Planning Commission Memorandum

Item: Public Hearing: Rezoning, Preliminary & Final Plat, and Site Plan – 2022-12 – Apartments – Vermillion St & 33rd St W

HASTINGS DEVELOPMENT

Elevation Drawings

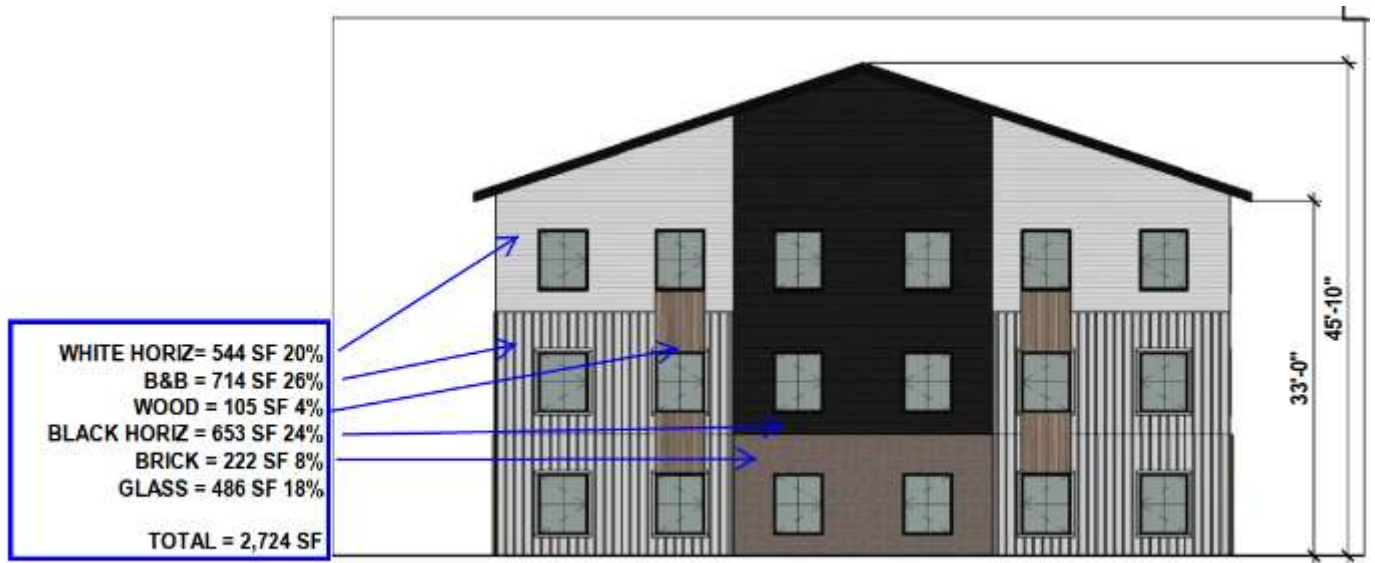
All elevations meet the minimum requirements of class 1 (glass and brick) and class 2 (fiber cement panels and siding or equivalent). There are no class 3 building materials proposed on the apartment buildings. The garages are proposed to have black asphalt shingles and white horizontal fiber cement siding or similar.

SITE PLAN

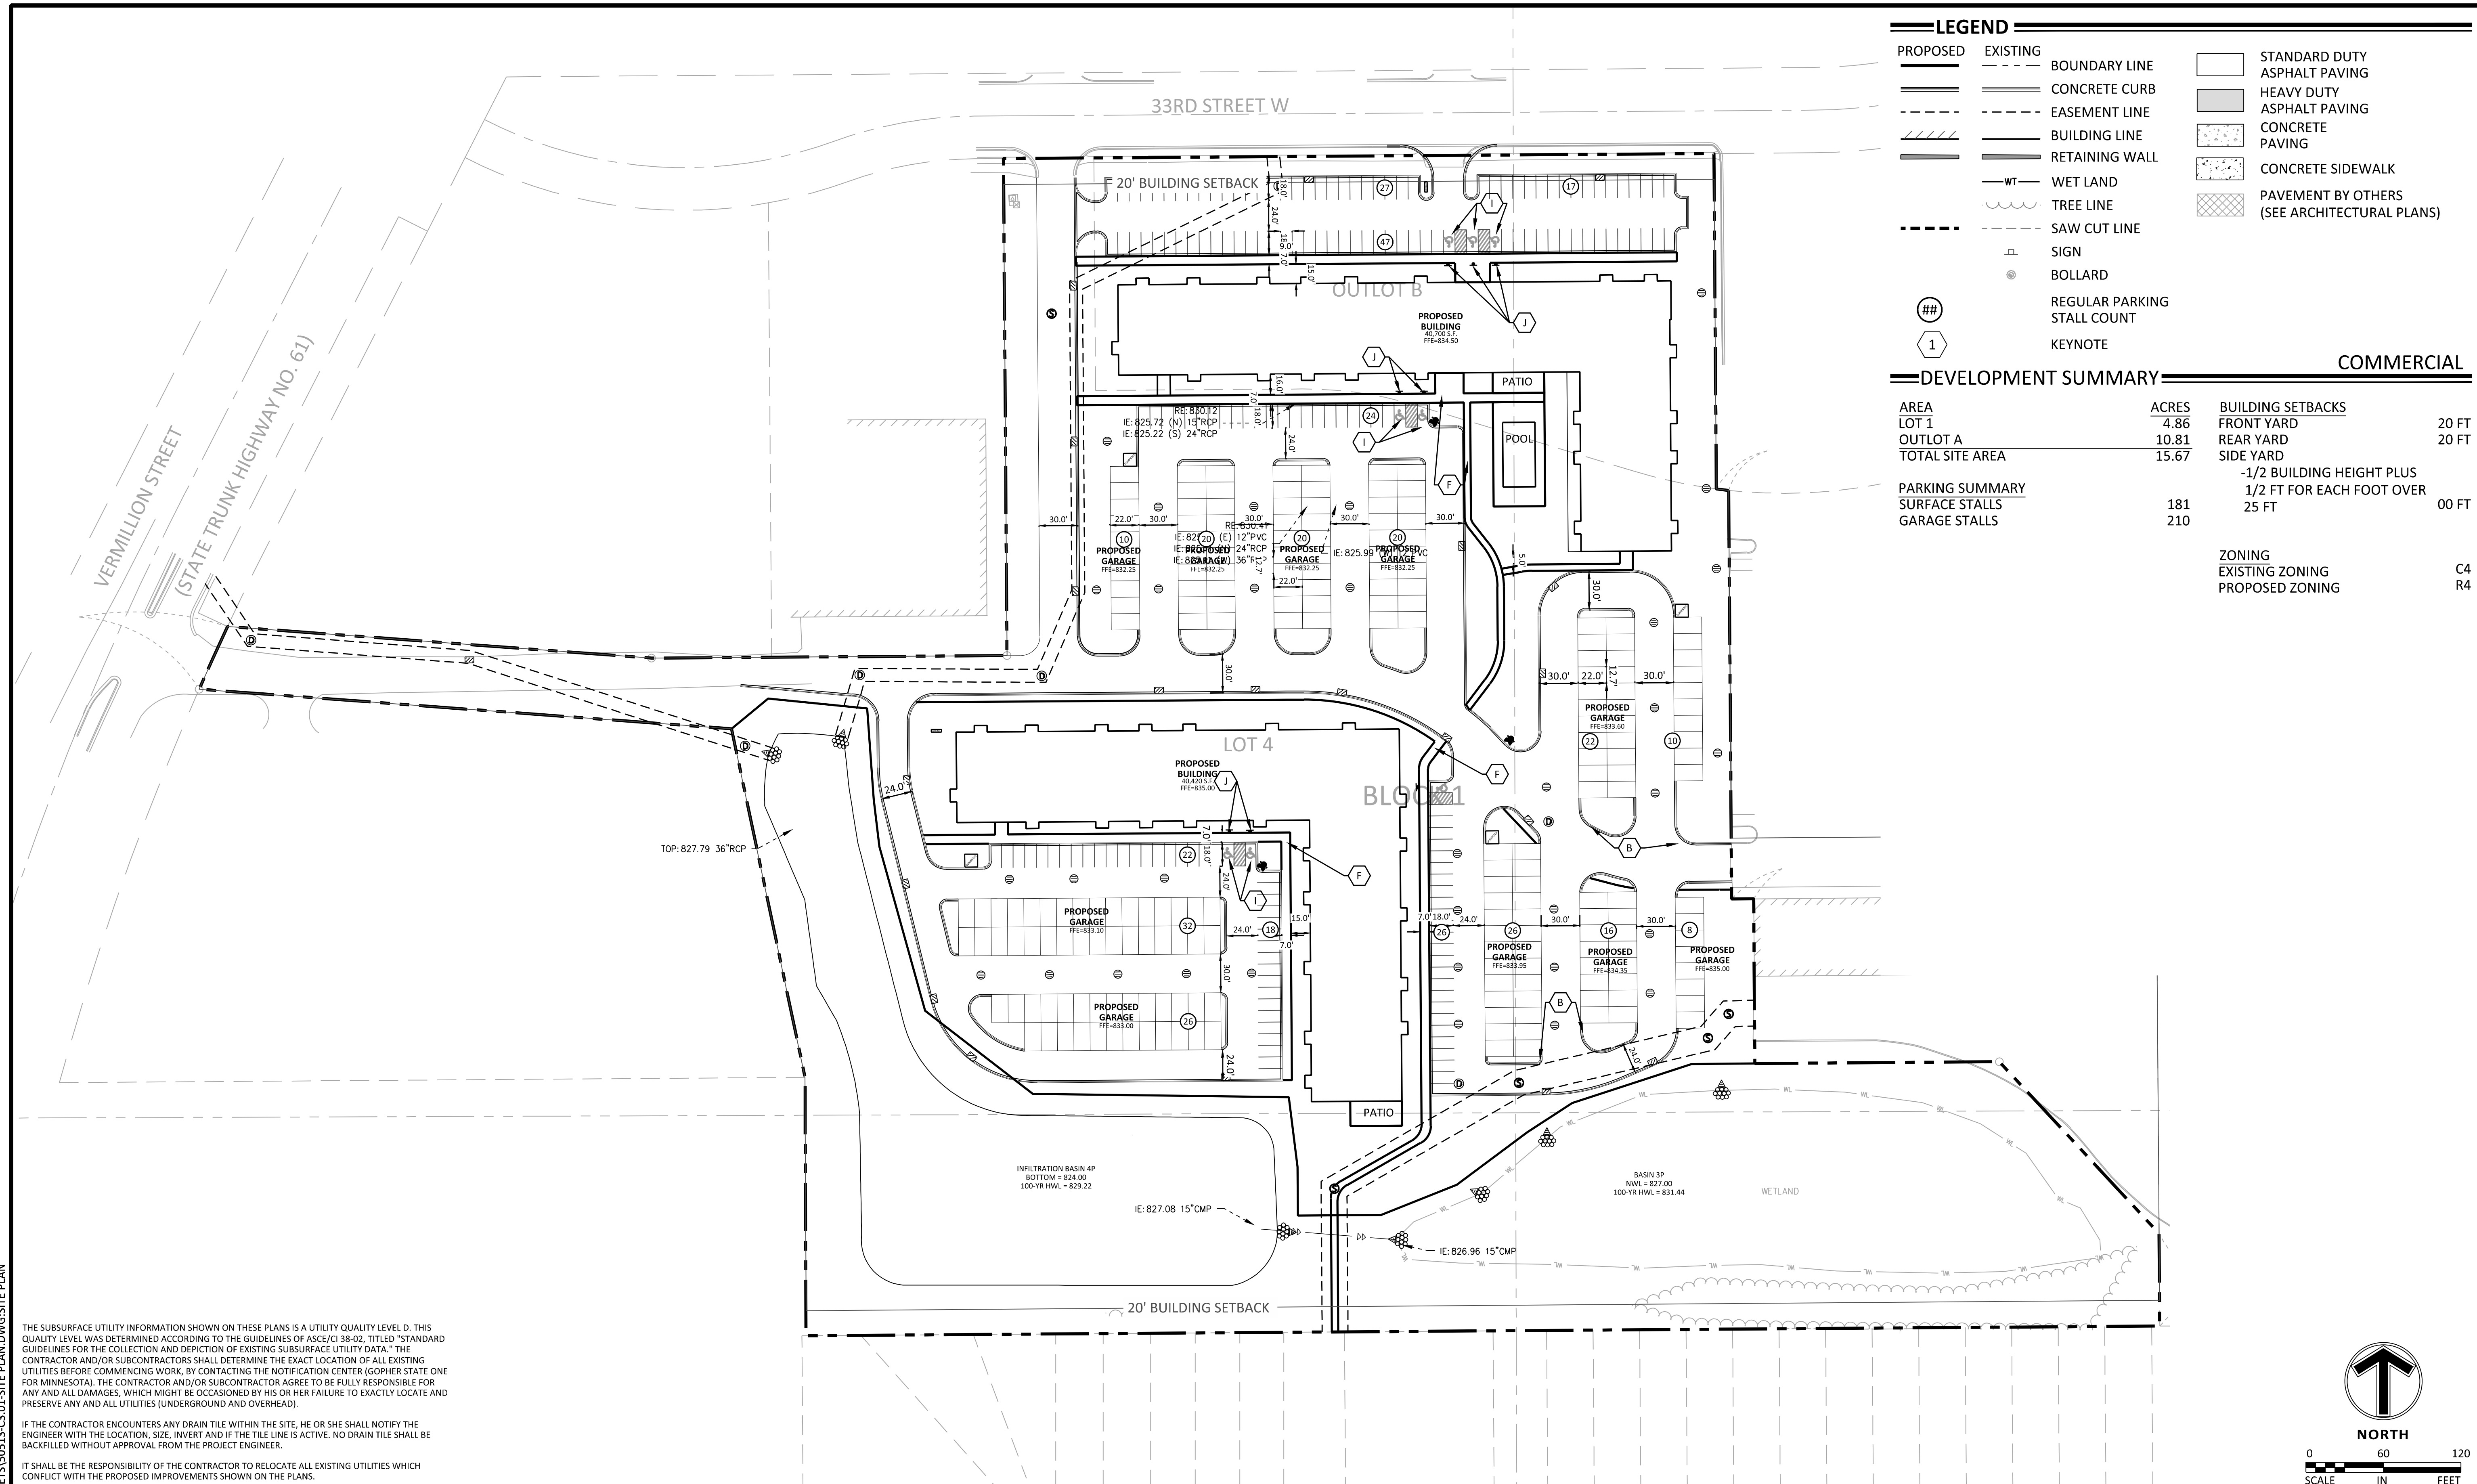
Some sidewalk connections are needed from the front of building two to the general site sidewalks. If building two has use of building one amenities, the main entrance or a secondary entrance should be considered on the north side of building two. This would significantly reduce the distance between the buildings.

Buildings with regular deliveries are required to have loading spaces. While there may not be regular deliveries for the building itself, there will surely be a lot of loading activity of people, packages, and mail. Due to the high number of units, delivery vehicles may be there for some time. Without a loading zone, the delivery vehicles will block parking spaces, garages, and drive isles. Loading zones near the main entrances would affect the proposed parking layout, but are necessary.

The current parking standards are two spaces for each unit. With 211 units proposed, 422 parking spaces are required by ordinance. The site plan shows 391 total spaces on the site. Garage stalls make up 210 and the remaining 181 spaces are surface stalls. This is a rate of 1.85 spaces per unit. The applicant believes that is adequate for the project based on their experience. As an ordinance requirement, the minimum parking requirement must be satisfied. Available off-street parking within close proximity is allowed to satisfy the requirement.

Staff believes the landscaping meets the ordinance requirements. At least one landscape island in needed on the south side of the north parking lot.

- 6) In addition to the landscaping shown on the plan, at least one landscape island is required on the south side of the north parking lot.
- 7) A right-of-way permit is required for any work in the public-rights-of-way.

- b. Payment of \$219,920 for cash in lieu of parkland dedication.
 - c. Payment of \$102,335 for sewer interceptor fees.
- 15) Connect the front of building two, to the site sidewalk system.

- 16) Include loading zones at the entrees of both buildings.
- 17) Submit a photometric plan .5 foot-candle adjacent to residential and auto switching controls.
